Document Tracking Number: 14C-2-29

RECORD OF UFPQAPP-SAP MODIFICATION

Name of Site / Field Event: US Magnesium / Site-wide Hydrologic Investigation

Modified SAP Section(s): September 2013 OU-1 Phase 1A SAP Worksheet #14, Table 14-1,

The five deeper zone groundwater sampling locations are shown in Figure 14-C-2-29 and are listed in the following table consistent with Table 14-1 of the Phase 1A SAP:

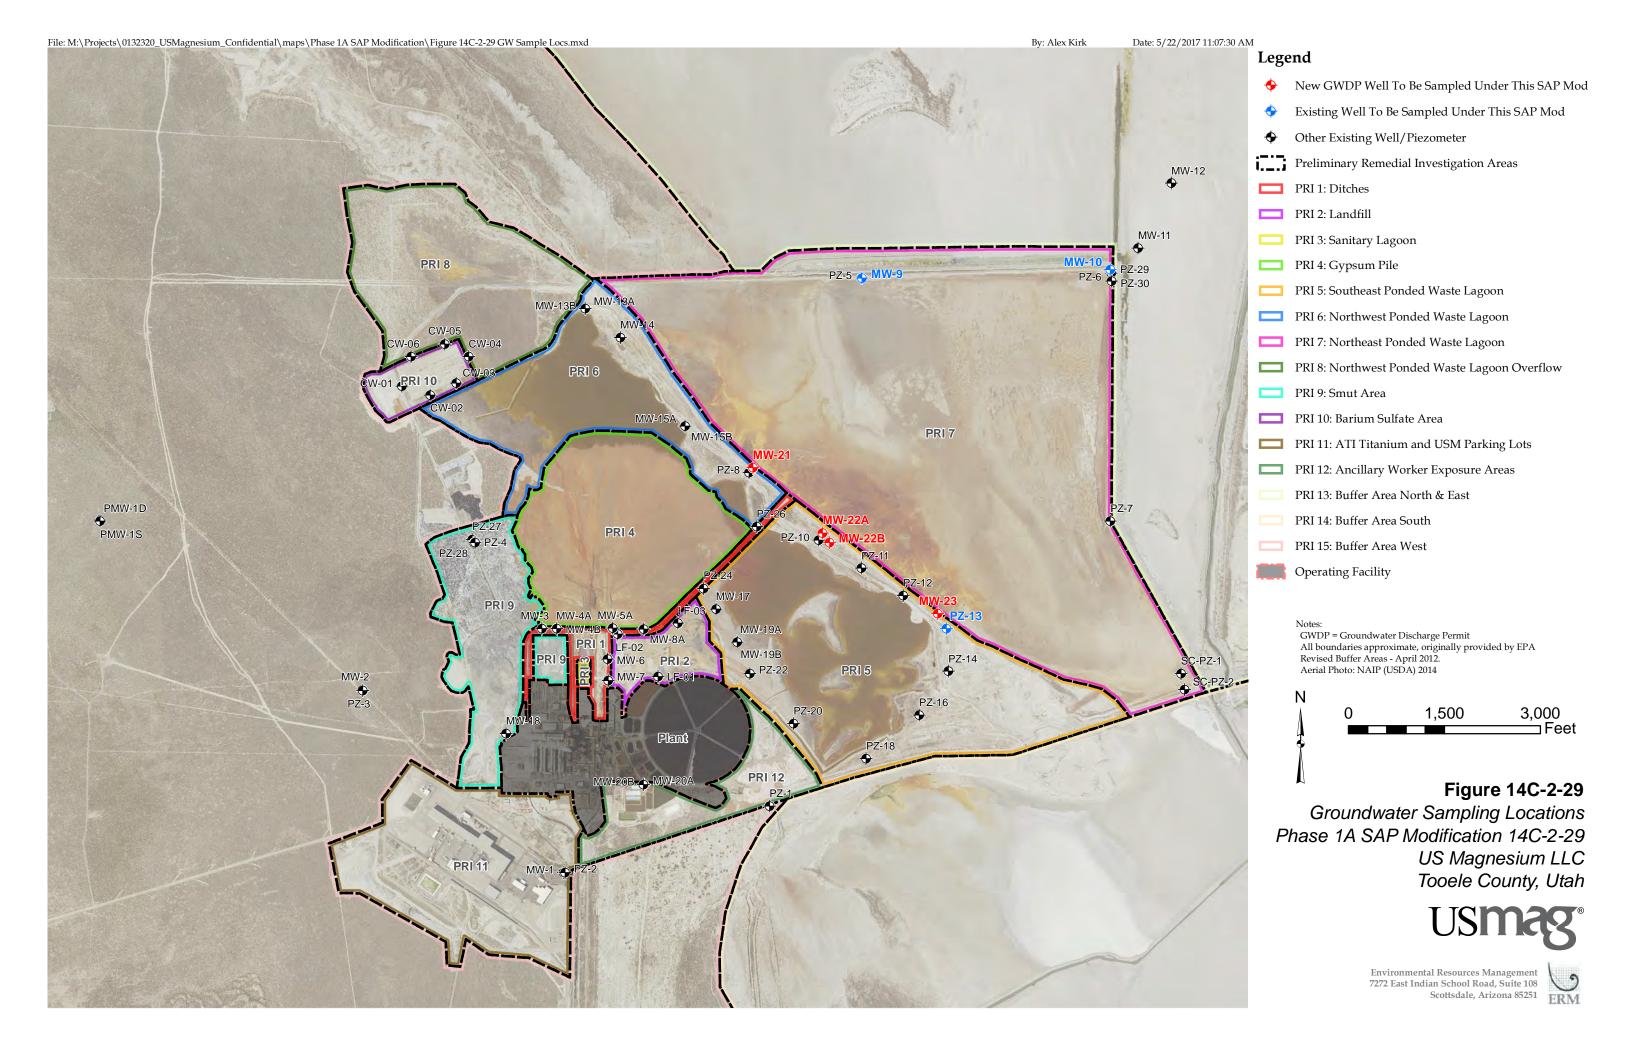
ERM will collect groundwater samples from five deeper zone monitoring wells to evaluate whether the deeper zone of shallow aquifer is impacted by groundwater COPCs or surface water COPCs/COPECs. Two of the monitoring wells are existing (installed in 2004) and the other three wells will be installed by US Magnesium in 2017 during a field program to resolve key data gaps for a Groundwater Discharge Permit (GWDP) Application (Stantec, 2017). ERM will also collect groundwater samples from one existing and one new shallow zone monitoring wells to provide baseline groundwater quality data for use in GWDP Application and as additional data points for evaluating nature and extent (N&E) of groundwater contaminants for the RI.

Sample Location ID	Sample Media	PRI Area ¹	Figure Number	X ²	Y 2	Rationale
MW-9	Groundwater	7	14C-2-29	1303820	7512001	To collect samples of groundwater from existing wells screened in the deeper zone aquifer hydraulically downgradient of the Old Waste Pond for Site
MW-10	Groundwater	7	14C-2-29	1307700	7512137	Characterization and to confirm that the deeper zone aquifer is not impacted by COPCs/COPECs.

Sample Location ID	Sample Media	PRI Area ¹	Figure Number	X ²	Y 2	Rationale
MW-21	Groundwater	6	14C-2-29	1302027	7508985	To collect samples of groundwater from new wells screened in the deeper zone aquifer hydraulically downgradient of
MW-22B	Groundwater	5	14C-2-29	1303120	7507925	the Current Wastewater Pond for Site Characterization and to confirm that the
MW-23	Groundwater	5	14C-2-29	1305111	7506550	deeper zone aquifer is not impacted by COPCs/COPECs.
PZ-13	Groundwater	5	14C-2-29	1305136	7506525	To collect a sample of groundwater in the upper shallow zone for GWDP
MW-22A	Groundwater	5	14C-2-29	1303100	7507945	Application baseline water quality and for groundwater N&E for the RI.

Typical Construction Detail for New Wells MW-21, MW-22B, and MW-23

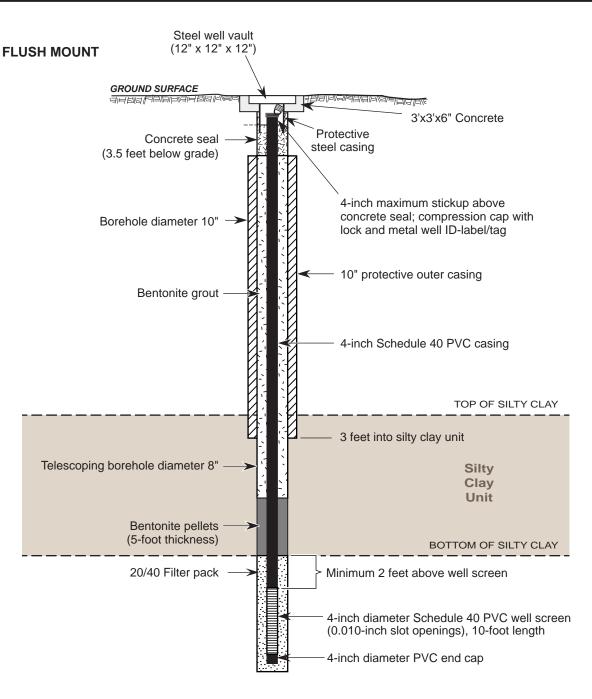
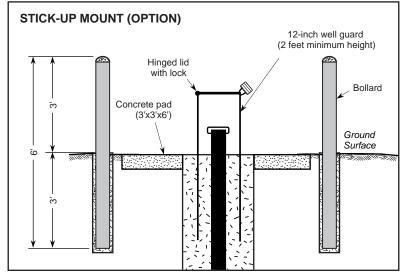
- Wells MW-21, MW-22B, MW-23 will be screened across the first water-bearing zone encountered
 below the confining silty clay unit. To allow for the sand pack, the ten-foot screens are expected to
 begin approximately two feet below the silty clay unit; however, the actual screened interval for each
 well will be based on observed lithologies as determined in the field by the US Magnesium GWDP
 contractor (Stantec) with field consultation from USEPA and UDEQ.
